## SUTHERLAND SHIRE COUNCIL ASSESSMENT REPORT

Panel Reference	2017SSH019
DA Number	DA17/0467
LGA	Sutherland Shire
Proposed Development:	Refurbishment and restoration of Heathcote Hall, construction of 35 townhouses and 20 apartments, associated landscape works and 56 lot strata subdivision
Street Address:	Lot 1 DP 725184, Lot 2 DP 725184 (No. 1-21) Dillwynnia Grove, Heathcote
Applicant/Owner:	Ink Architects Pty Ltd
Date of DA lodgement	28 April 2017
Number of Submissions:	264 groups/individuals to the first notification period and 54 groups/individuals from second notification period.
Recommendation:	Deferred Commencement
Regional Development Criteria (Schedule 7 of the SEPP (State and Regional Development) 2011	Schedule 4A of the Act (in accordance with correct version of the EP&A Act at the time of lodgement)
List of all relevant s4.15 (1)(a) matters	<ul style="list-style-type: none"> <li>• State Environmental Planning Policy 55 – Remediation of Land</li> <li>• State Environmental Planning Policy 65 – Design Quality of Residential Apartment Development</li> <li>• Heritage Act 1977</li> <li>• Rural Fires Act 1997</li> <li>• Sutherland Shire Local Environmental Plan 2015</li> <li>

*Amended site layout as proposed in amended plans identifying the carriageway and Heritage Curtilage*

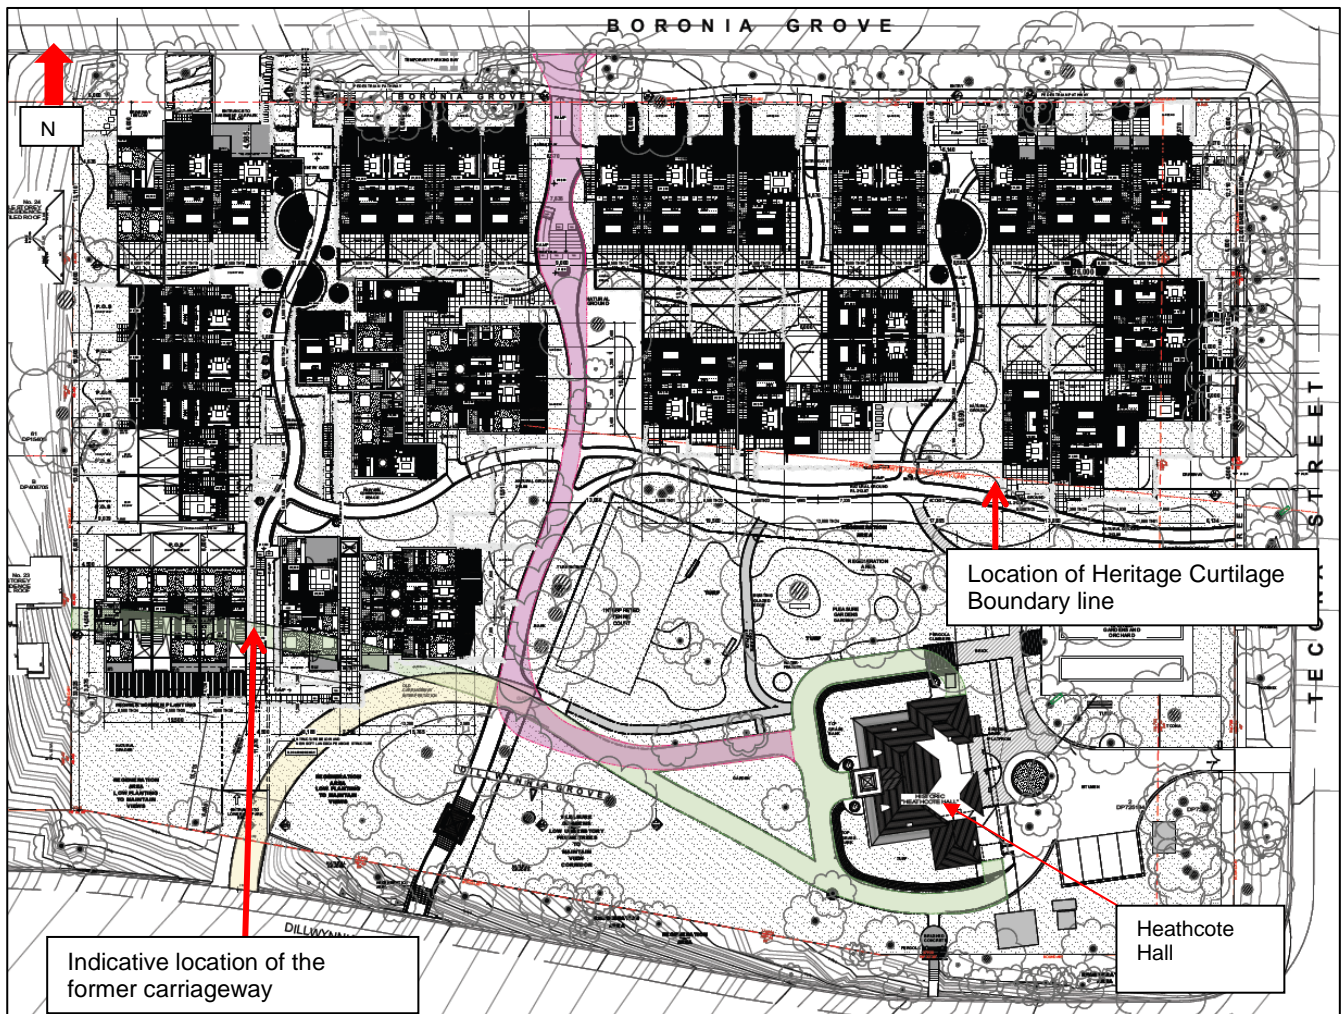
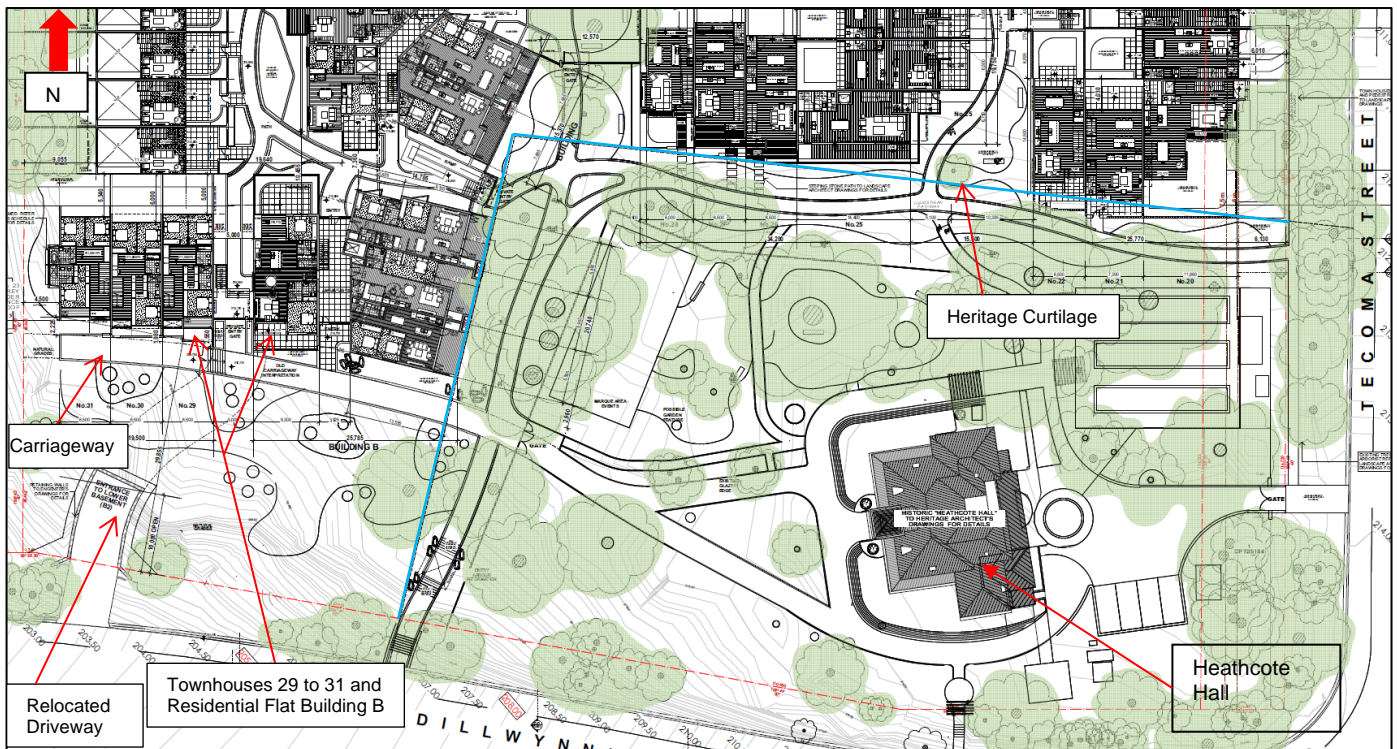
However, there were design modification imposed in these original GTAs, whereby the Heritage Council required amendments to various aspects of the development as they encroached into the setback and curtilage areas as identities in the CMP. Encroachments can be seen below on the original plan submitted with the application. Further the setbacks and curtilage were not clearly identified on the plans.

Council advised the Heritage Council that any changes required by the GTAs would need to be resolved prior to determination. The Heritage Council attended the workshop held at Council, and provided some advice and clarification to both Council and the applicant regarding the general terms. Of particular importance was that the applicant would be required to accurately overlay the setbacks and curtilage as identified in the images from the CMP above, as well as locate dwellings further north to align with the curtilage and setbacks. The Heritage Council advised they were satisfied with retaining a driveway entry to the basement from Dillwynia Grove, subject to a suitable redesign and the driveway being relocated as far west as possible, to minimise visual impact of this entry. The applicant was advised by the Heritage Council that the carriageway should be kept free of all above ground structures.

In response the applicant relocated a number of dwellings further north to address the GTAs. In particular Residential Flat Building B and Townhouses 20-31 were repositioned further north, as can be seen on the plan below.

Western elevation of Residential Flat Buildings A and B (as originally proposed)

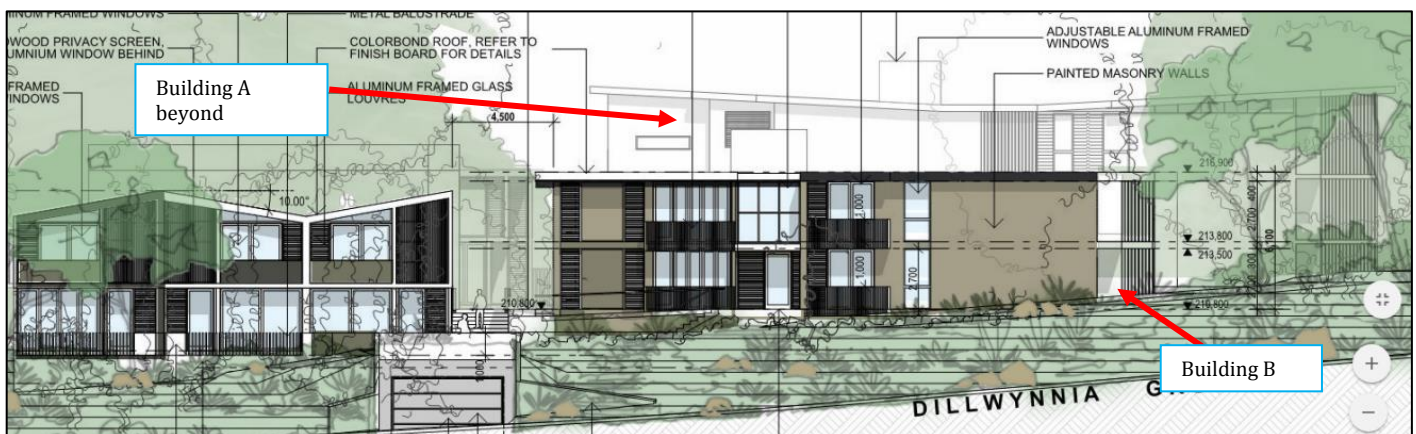
As seen in the figures below the height of Building A as per the original plans and original Clause 4.6 variation request measured 8.8m to the roof at its highest point and 9.8m to the lift overrun. Buildings A and B can be seen below as originally proposed, with Building B below the 8.5m height limit and presented in a form not unlike the town houses in bulk and scale.

Several concerns were expressed in Council's letter to the applicant, the first GTAs issued by the Heritage Council and follow up workshop and meeting. These matters included the non-compliant height of Building A; encroachment of the heritage curtilage contained within the Conservation Management Plan (CMP); and the reduced setbacks along Boronia Grove.

The applicant's response was to remove buildings from the Heritage carriageway and increase setbacks to Boronia Grove, one of the west facing townhouses was deleted and both RFBs re-designed and repositioned. In order to minimise the resulting loss of dwellings the applicant proposed an additional level to Building B increasing it from 2 storey to 3 storeys.

*Western Elevation of Residential Flat Building A and B (as amended)*

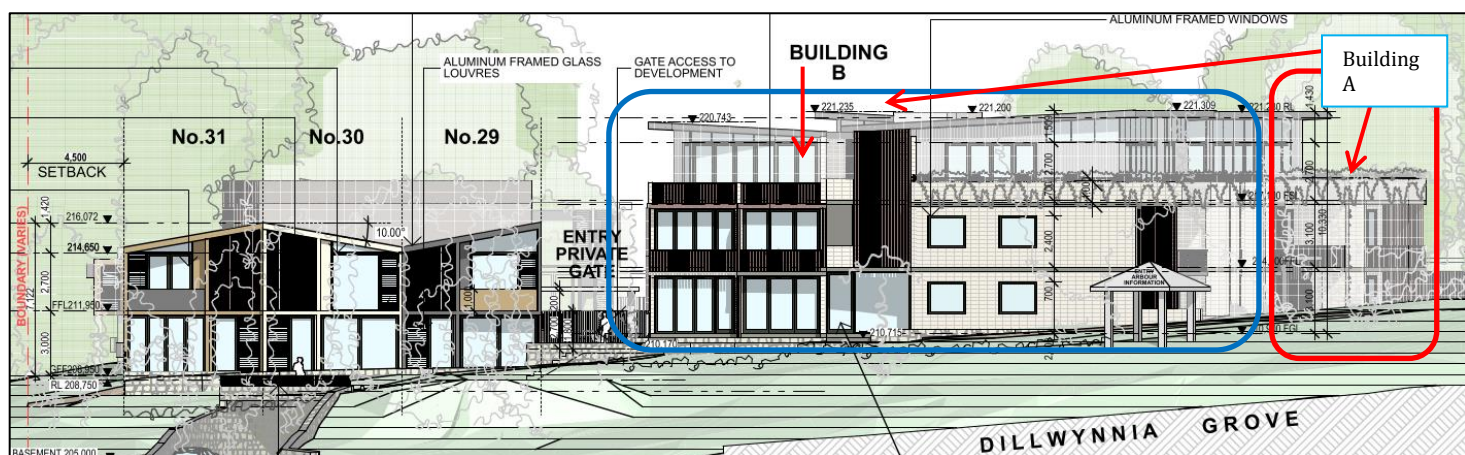
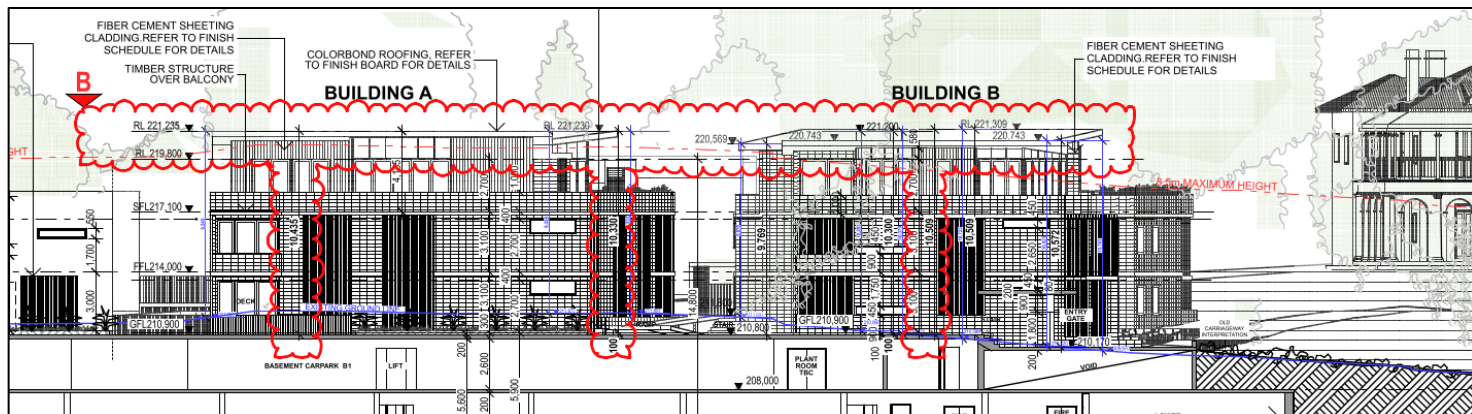
The applicant presented this additional level to Building B, at the workshop and subsequent meeting. Council advised on both occasions that if a third storey to Building B was to be considered, it would need to be well designed, recessive in nature at the third level, and responsive to the context and setting. Council advised that it would assess the built form and response to the context once final plans had been submitted. The amended plans show the apparent flat roof of Building B amended to replicate the butterfly roof form of Building A. Amended elevations have been included below. The revised scheme presents an increased roof height of Building A to 9.545m and Building B to 10.763m. Townhouses 30 and 31 adjacent to Building B are also above the 8.5m height control in the modified plans.

The reduction in height of Building will provide a transition to the residential development to the south and west, and the significant heritage areas to the south and east. There is no justification for townhouse 30 and 31 to be above the height limit and a condition is recommended that these be a maximum of 8.5m in height.
